MEMO

Date: March 7, 2011
To: Steve Lester, Western Region
From: Craig Tesch and Dennis Owsley, Hydrology Section, State Office
cc: Sean Vincent and Rick Raymondi
Subject: Technical Review of Orchard Ranch LLC Application #63-32703

Figure 4. Water level change from 1983 to 2009 within the IDWR Mountain Home monitoring network area.

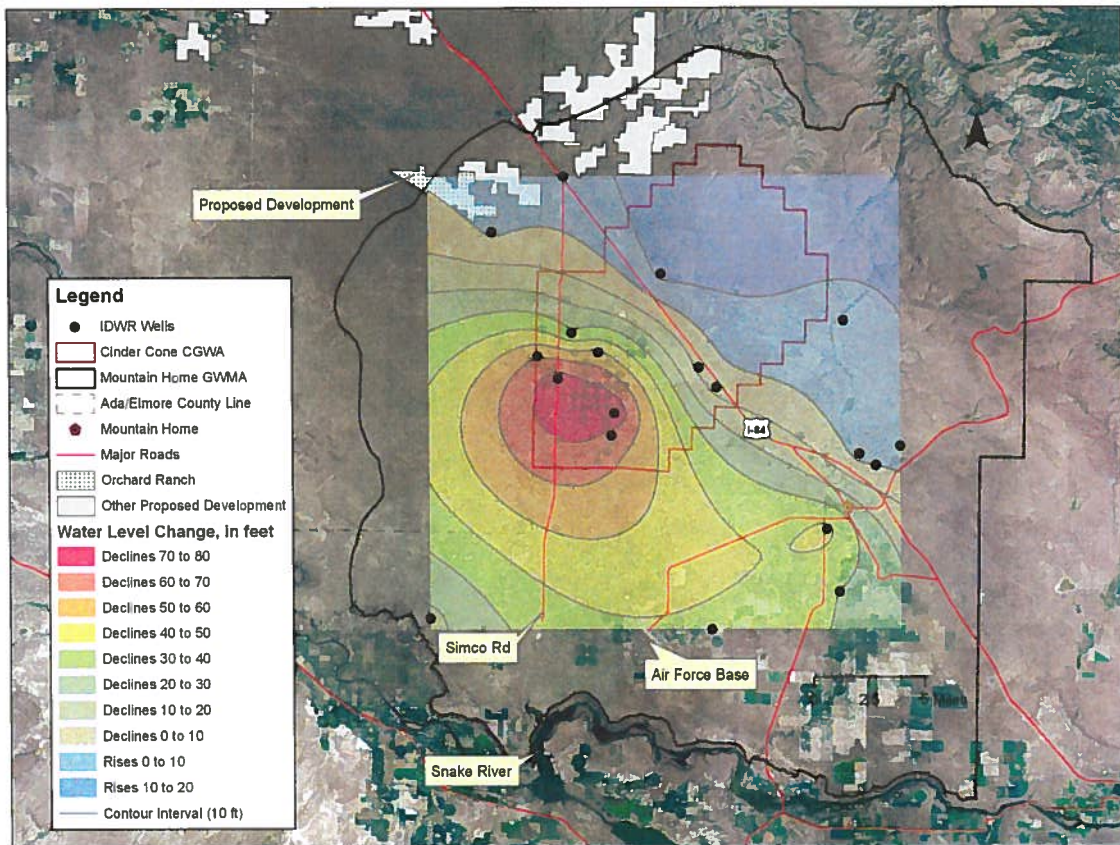
Water level data from wells in the Mountain Home network that were collected during the spring between 1983 and 2009 were recently compared by IDWR in order to determine water level trends (Figure 4). Water levels in 13 of the 19 wells (68%) were lower in spring 2009 than water levels measured in the spring of 1983. These thirteen wells show water level decreases ranging from 0.1 to 80 feet; declines greater than 50 feet were observed in five wells located in the southwest portion of the Cinder Cone CGWA.

Six of the nineteen wells (32%) show a rise in water level, and are primarily located northeast of the interstate. The increases range from 1 to 13 feet. The proposed POU and PODs are located in the vicinity of increasing water levels. The cause of differing trends in the area is poorly understood, and significant uncertainty exists due to a lack of hydrologic data in this area.

In contrast to the report developed by SPF in support of the water right application for the nearby Nevid residential development, SPF did not attempt to quantify water availability at the proposed site. SPF did not calculate a water budget or predict hydrologic impacts that would result from the proposed pumping. Instead, the consultant supports their conclusion that water is available for appropriation by discussing water level trends in area wells. SPF (2007, p. i) states that “Ground-water levels in the Orchard Ranch vicinity have been relatively stable water levels (*sic*) over the last 30 to 40 years.” It is important to note, however, that large water level declines have been experienced nearby in the Cinder Cone CGWA and Mountain Home GWMA (Figure 4). SPF (2007, p. 11) acknowledges water level declines approximately 6.5 miles to the south/southeast in the Cinder Cone CGWA: “The remaining three wells...show water level declines ranging from approximately 1 foot per year to approximately 2.5 feet per year.”

The source for differing trends in the area is currently unknown. Irrigation development near Simco Road in the southwestern portion of the CGWA is potentially a major contributor to declines in the area; however, northwest-trending faults mapped in the area

(Bond, 1978) may serve as partial barriers to flow and contribute to the difference in trends between wells north/northeast of I-84 and those south/southwest of I-84. Barriers can serve to increase drawdown from pumping and to limit aquifer recharge.

Figure 5. Location of the Orchard Ranch proposed POU relative to the SPF-calculated capture area for Elk Creek Canyon-Sterling Sage (referred to as the Nevid capture area), regional groundwater contours, and other proposed developments.

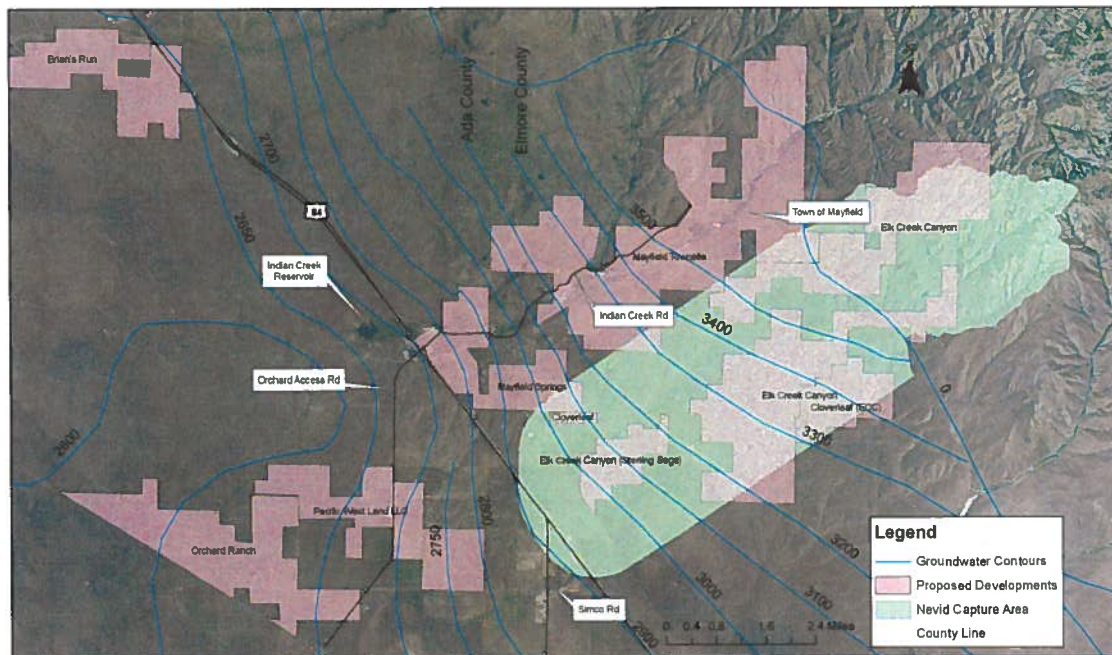
Orchard Ranch is downgradient of the capture area (Figure 5) for the Elk Creek Canyon-Sterling Sage residential development (also referred to as Nevid) that was recently granted a water right appropriation of 345 af (annual volume limit) and a 4.02 cfs maximum diversion rate (IDWR, 2009). In the final order it was determined that 811 af/year of recharge entered the area near the boundary and “A reduction in the minimum recharge estimate of 811 acre-feet to a lesser water availability of 345 acre-feet is reasonable given the factors that would prevent Nevid from capturing all the water recharged to ground water.” Subtracting the 345 af/yr appropriation from upland recharge results in 466 af/yr of outflow from the Nevid area. The IDWR Western Region memo accompanying the amended permit application for Orchard Ranch dated September 27, 2010, anticipates a diversion volume of 1,920 to 2,160 af annually and a maximum diversion rate of 9.6 cfs (6,955 aft/yr), both which exceed outflow from the Nevid area.

Figure 6. Water rights and groundwater flow contours in the Mountain Home GWMA.

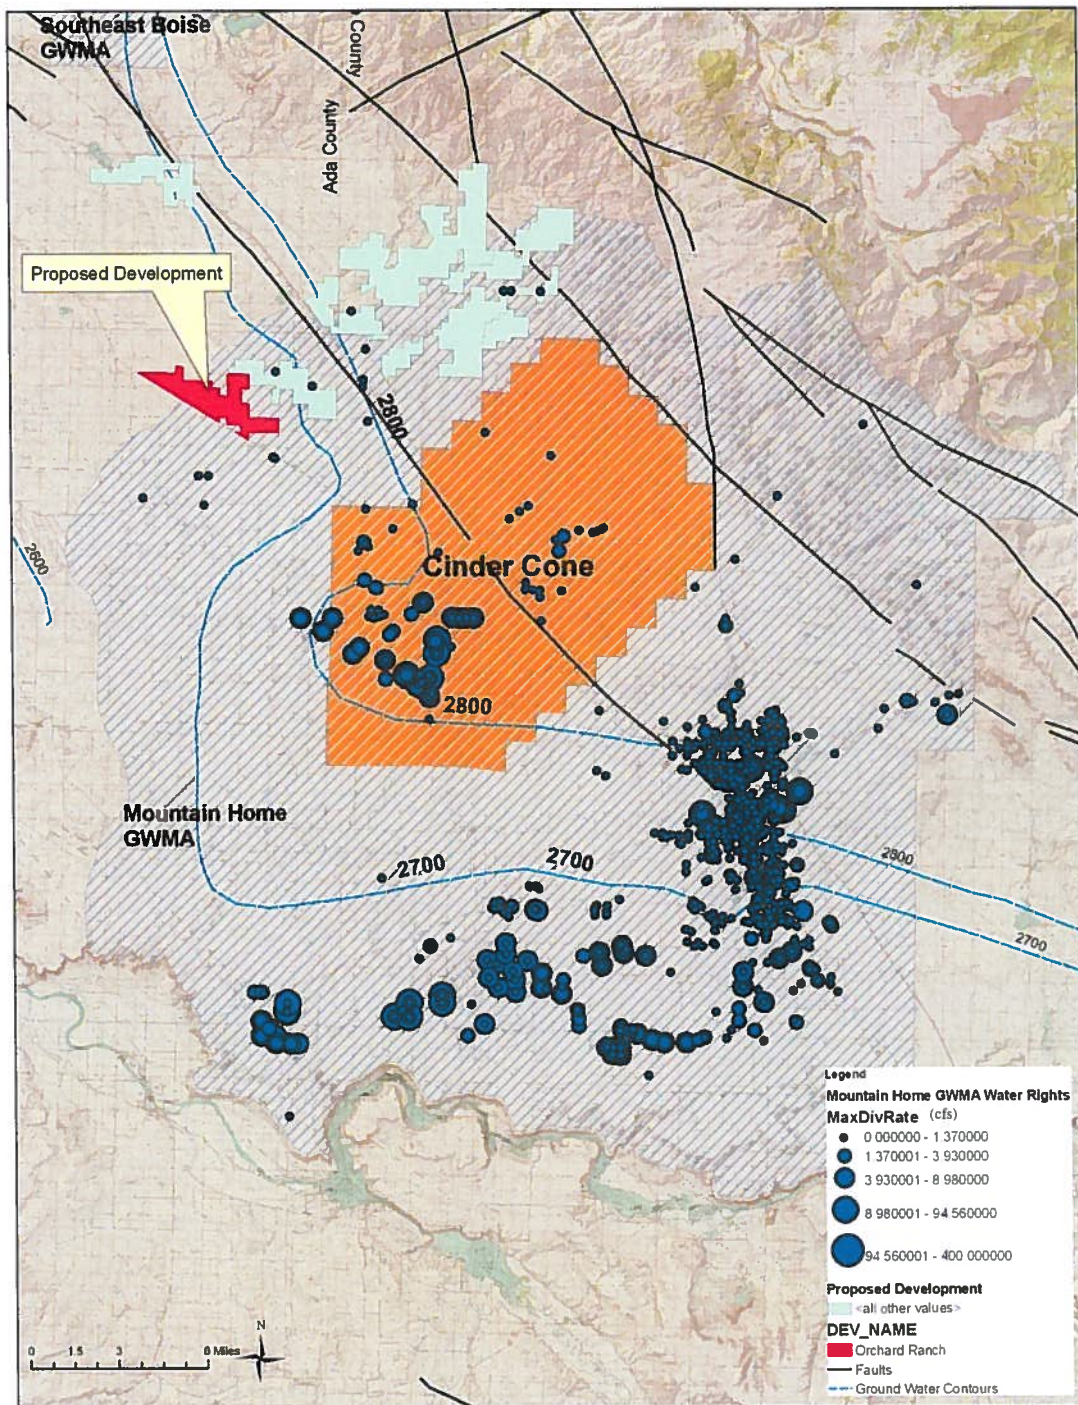
The current lack of stress on the aquifer in this particular area may explain the stable or rising water levels in the northern portion of the management area. As shown in Figure 6, less than one percent of the pumping within the Mountain Home GWMA occurs in the northern portion of the management area. There are seven water rights within three miles of the Orchard Ranch property boundary with a combined maximum diversion rate of 1.83 cfs. Orchard Ranch’s proposed appropriation of 9.6 cfs represents a 425% increase in potential withdrawals in that area.

It is unknown how the aquifer will respond to an increased stress, but it is reasonable to assume that the aquifer could respond similarly to what has occurred in the southern portion of the management area and in the southeast Boise area.
